Customer : CU-DAR001 Dart Helicopters Services	Drawing Name : BASKET RIB
Job Number : 47957	
Estimate Number : 10404	
P.O. Number :	Part Number : D31663
This Issue : 14/05/2009 S.O. No. :	Drawing Number : D3166 REV A2
Prsht Rev. : NC	Project Number : N/A
First Issue : / / Type : LARGE FAB ASSY	Drawing Revision : A2
Previous Run : 47073	Material :
Written By :	Due Date : 21/05/2009 Qty: 6 Um: Each
Checked & Approved By : <u>JUD09.05.14</u>	
Comment : Est. A 02.08.23 New issue KJ) Est Rev:B 09-01-23 as per DEO D3166-A2 DD verified by:EC

DESIGN #	DRAWN BY CP	DART AEROSPACE LTD HAWKESBURY, ONTARIO, CANADA	
CHECKED #	APPROVED #	DRAWING NO. D3166	REV. A SHEET 1 OF 1
DATE 02.07.10		TITLE BASKET HOOP	SCALE NTS
A	02.07.10	NEW ISSUE	
A1	04.04.08	38+/-1 was 36.0

DRAWING NO. D3166	TITLE BASKET HOOP	REV.A1	DART AEROSPACE LTD ENGINEERING ORDER		D.E.O. NO. D3166-A-2	SHEET NO. 1 OF 1	SCALE NTS
DRAWN AJS	CHECKED ls	MFG. APPR. M	APPROVED MP		DE APPR. H		
DATE 08.12.11	DATE 08.12.15	DATE 08/12/15	DATE 08/12/16		DATE 08.12.16

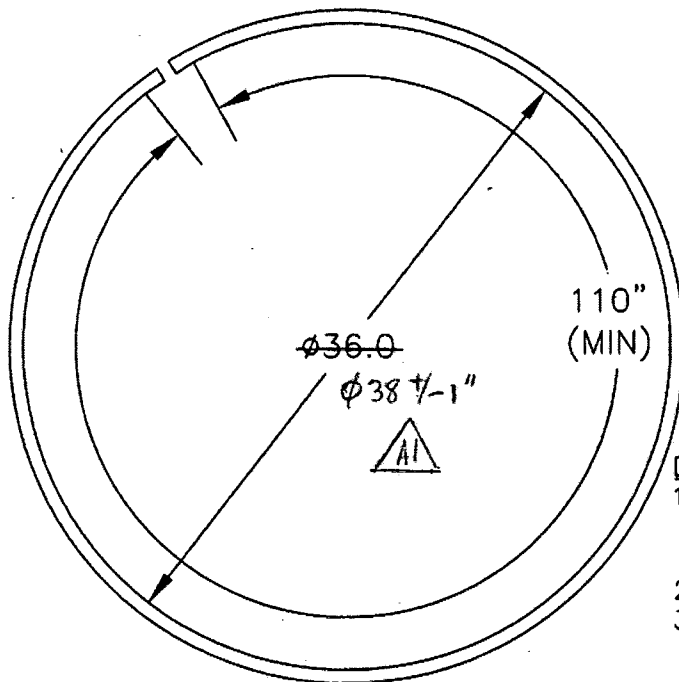
1) MODIFY MATERIAL NOTE FOR D3166-1 AS SHOWN:

2) MODIFY MATERIAL NOTE FOR D3166-3 AS SHOWN:

REASON: SEE PAR 08-005

IS:

1) MATERIAL: AISI 304/316 SS, 3/4 X 3/4 X 0.065 WALL SQUARE TUBING,
60.00" LONG
REF. DART SPEC M304TS0.750W.065

WAS:

1) MATERIAL: AISI 304/316 SS SQUARE TUBING,
0.75" x 0.75" x 0.063 WALL, 60.00" LONG
(REF DART SPEC. M304TS0.750W.063)

IS:

1) MATERIAL: AISI 304/316 SS, 3/4 X 3/4 X 0.065 WALL SQUARE TUBING,
120.00" LONG
REF. DART SPEC M304TS0.750W.065

WAS:

1) MATERIAL: AISI 304/316 SS SQUARE TUBING,
0.75" x 0.75" x 0.063 WALL, 120.00" LONG
(REF DART SPEC. M304TS0.750W.063)
